Idle Free System Harness Wiring

NOTICE: New Installation Requirement

New wire harness from UBB to APU required for Condenser Fan Operation.

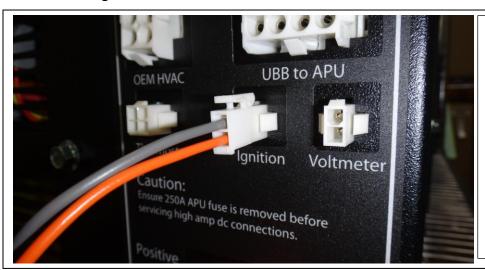
There is a new single **ORANGE** wire that is part of the Ignition harness. It is plugged into the UBB Ignition port that needs to be routed down to the back of the APU. Please see images below.

UBB: Insert new harness into the Ignition port.

Note: this new harness has two wires **Orange** and **Gray**.

The **Orange** Wire goes to the APU.

The Gray wire goes to the truck ignition

APU: Insert new **Orange** wire into the single **Black** wire terminal.

This is located on the back of the APU.
